Staff Report for PLPR-2607-0002

Application Type: MU-C Planning Review

Location of Subject: 4088 Haines Road

The applicant is proposing a 1-story, 5,050 sq. ft. bank with drive-through canopy.

TREE
REPLACEMENT
PLAN

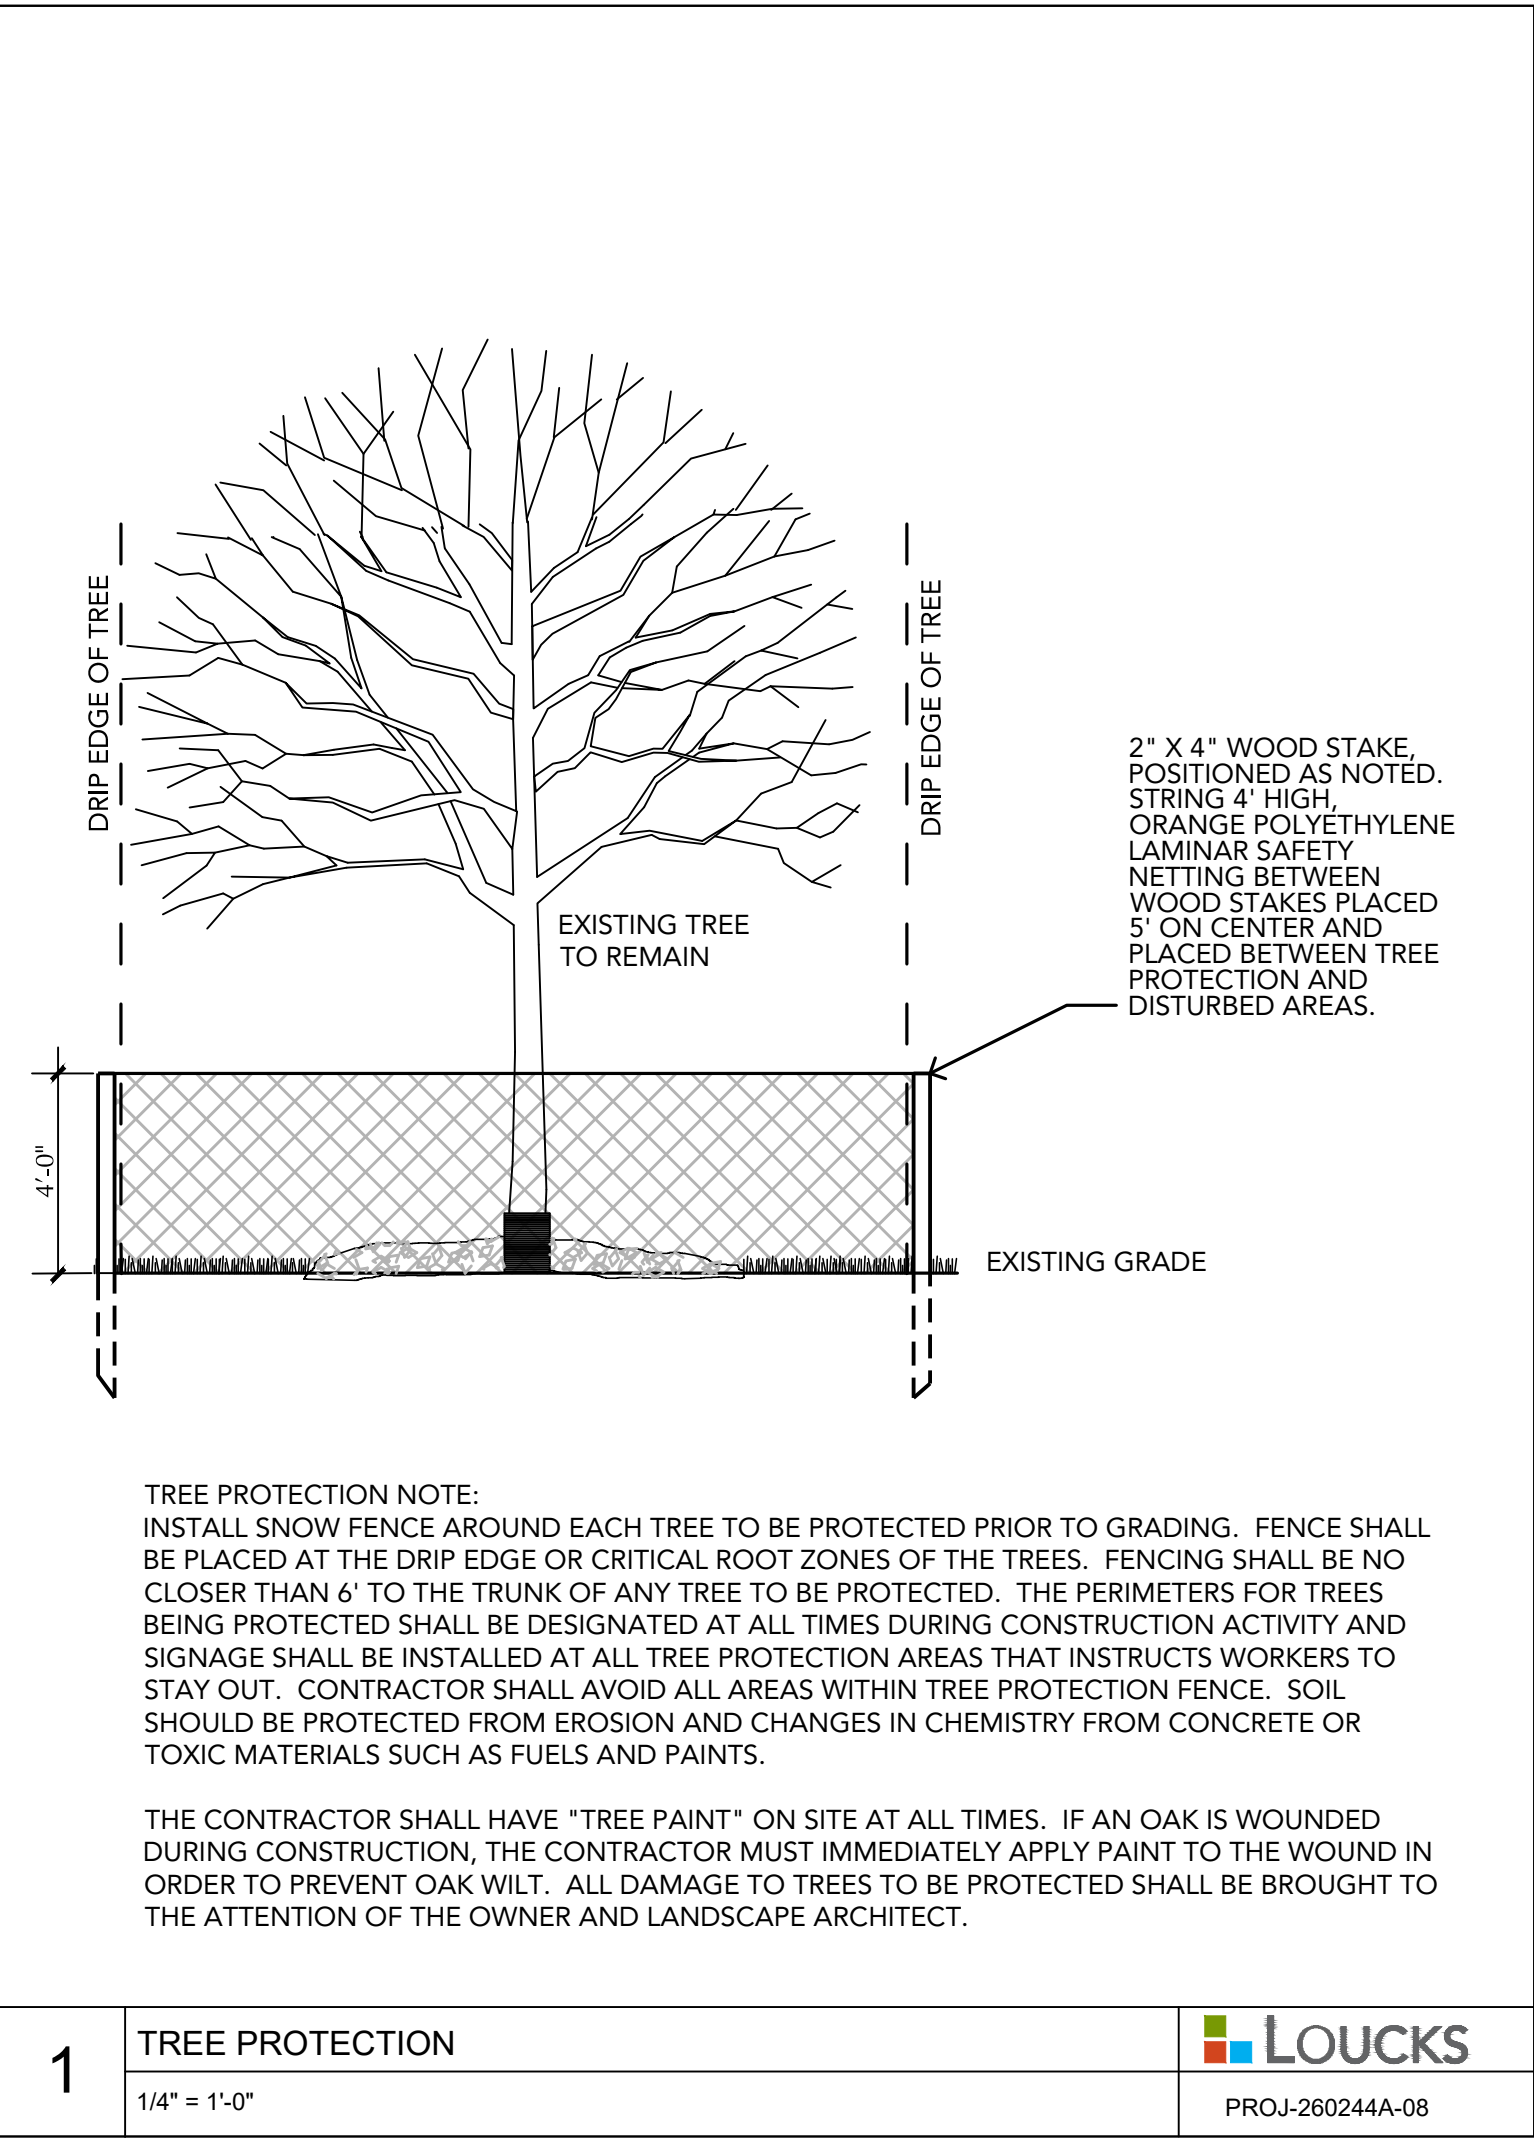
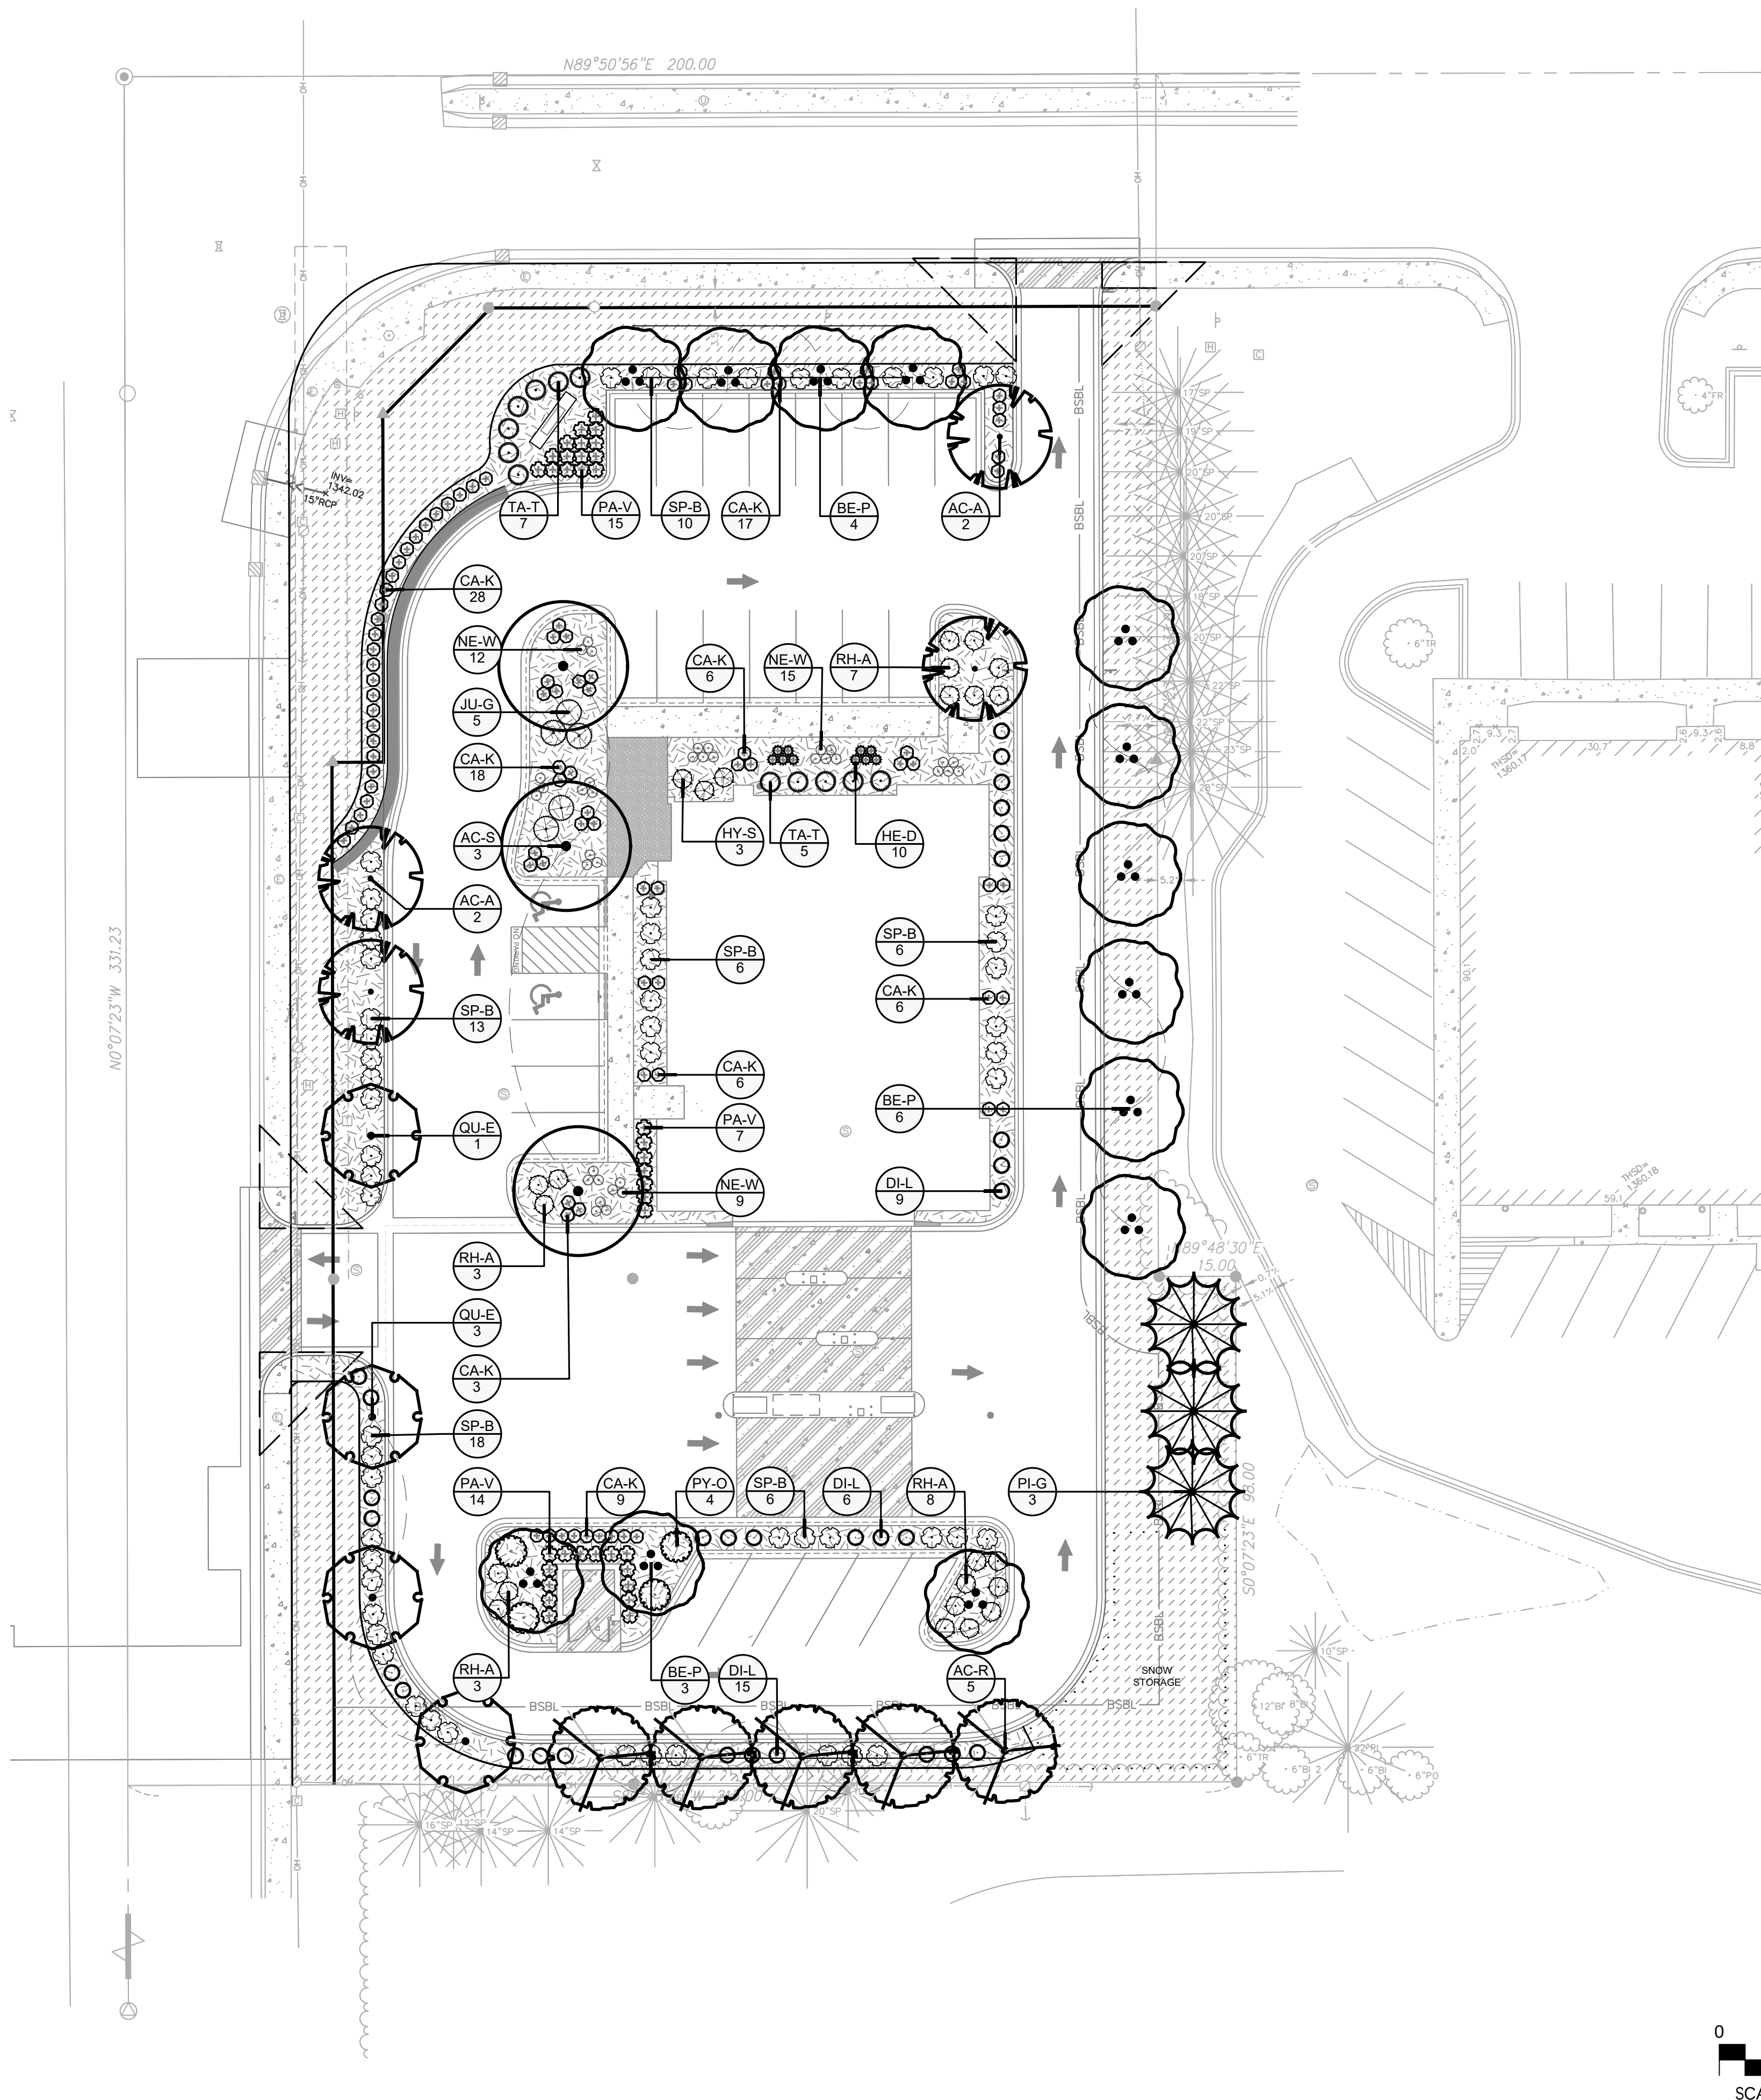
6. Section 50-25 (Landscaping and Tree Preservation) – The applicant has submitted a landscape plan along with a tree replacement plan. The applicant is proposing to remove 420" of trees with replacement at 84.5". The City Forester will need to confirm if this rate of replacement is acceptable. It is not anticipated that there will be extensive disturbance of the existing natural resources as the site was previously developed as single family homes. The submitted landscaping plan meets the standards in this Section. Proposed parking lot tree canopy coverage, internal parking lot islands, and street frontage landscaping all meet or exceed the requirements. The proposed tree replacement plan meets the requirements for replacement and indicates fencing to protect neighboring trees.

1. Applicant shall construct and maintain the project as identified in the attached exhibits.
2. The tree replacement plan shall be approved by the City Forester.
3. Any alterations to the approved plans that do not alter major elements of the plan may be approved by the Land Use Supervisor without further Planning Commission action; however, no such administration approval shall constitute a variance from the provisions of Chapter 50.
